SUBDIVISION COMMITTEE
METROPOLITAN AREA PLANNING COMMISSION

AGENDA ITEM NO. 7

STAFF REPORT
(Preliminary Plat-Approved 6/5/97)

CASE NUMBER: S/D 97-37 - LINDSAY'S ORCHARD

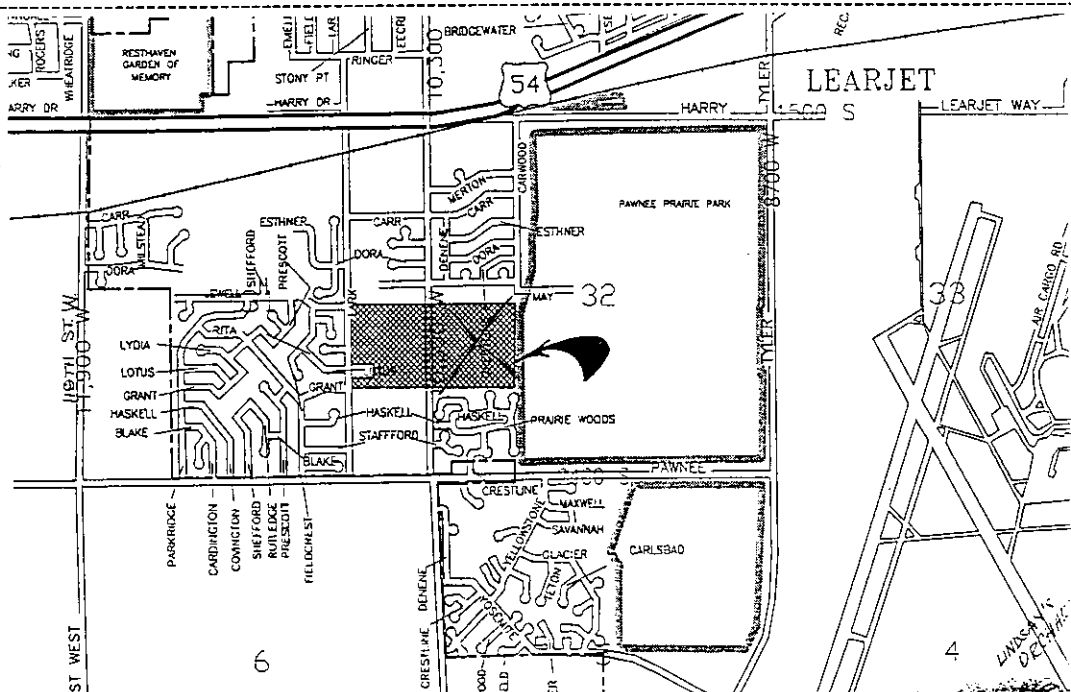
- A. The applicant shall guarantee the extension of sanitary sewer to serve the lots being platted.
- B. The applicant shall guarantee the extension of City water to serve the lots being platted.
- C. The applicant shall guarantee the paving of the proposed interior streets.

Access Control for Lot 1, Block 3 to Maize Road should be provided. Complete access should be granted for the residential lots along Maize.

- D. Sidewalks should be provided on one side along Rita, Stony Point Ln, and Jewell.
- E. The applicant shall guarantee the construction of any drainage improvements required by the platting of this property, including storm sewers. Minimum pad elevations should be established on the lots near the drainage ditch.

- H. **Representatives from the City Fire Department** comment that the street name "Fieldcrest" should be changed to "Rita".
- I. **City Engineering** indicates that the applicant's drainage concept has been approved.
